Access Compliance Report

Public Rights-of-Way

Intersection ID: 51539	Main Street: TRIEG_DR	Cross Street: GLENBURN_LN	Location:	N
ADA ID: 58D91597F294	Ramp Type: PerpDiag	Initial Pass/Fail: Fail	Overall Compliance: No	Severity Score: 8.75
Codes/Mitigation Info/Possible Solution		Field Measurements/Component Compliance

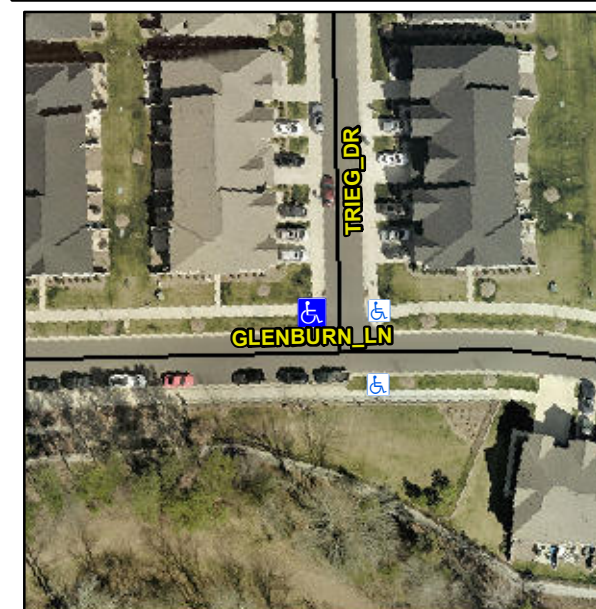
Not Found, R304.5.1

Compliance	Description	Data	Compliance	Description	Data
N/A	Ramp Length (in)	62.0	Yes	Ramp Slope (%)	5.7
No	Ramp Width (in)	47.0	Yes	Ramp XSlope (%)	1.6
N/A	Flare Type LT	N/A	N/A	Flare Type RT	N/A
N/A	Flare Slope LT (%)	N/A	N/A	Flare Slope RT (%)	N/A
N/A	Flare Traversable LT?	N/A	N/A	Flare Traversable RT?	N/A
N/A	Landing Length (in)	N/A	N/A	DWS Provided?	N/A
N/A	Landing Width (in)	N/A	N/A	DWS Contrast?	N/A
N/A	Landing Slope (%)	N/A	N/A	DWS Length (in)	N/A
N/A	Landing X Slope (%)	N/A	N/A	DWS Full Width?	N/A
N/A	Landing Curb? (Y/N)	N/A	N/A	DWS Offset (in)	N/A
N/A	Shared Landing?	N/A			
N/A	Gutter Ponding?	N/A	N/A	Gutter Slope (%)	N/A
N/A	Gutter Lip Ht (in)	N/A	N/A	Gutter X Slope (%)	N/A
N/A	Painted X Walk1?	No	N/A	Painted X Walk2?	No
	X Walk 1 Direction	To E		X Walk 2 Direction	To S
N/A	X Walk 1 Width (in)	N/A	N/A	X Walk 2 Width (in)	N/A
	X Walk 1 Slope (%)	1.1		X Walk 2 Slope (%)	0.8
	X Walk 1 X Slope (%)	0.4		X Walk 2 X Slope (%)	2.6

Remove & Replace Curb Ramp With Two New Directional Ramps or Equivalent.
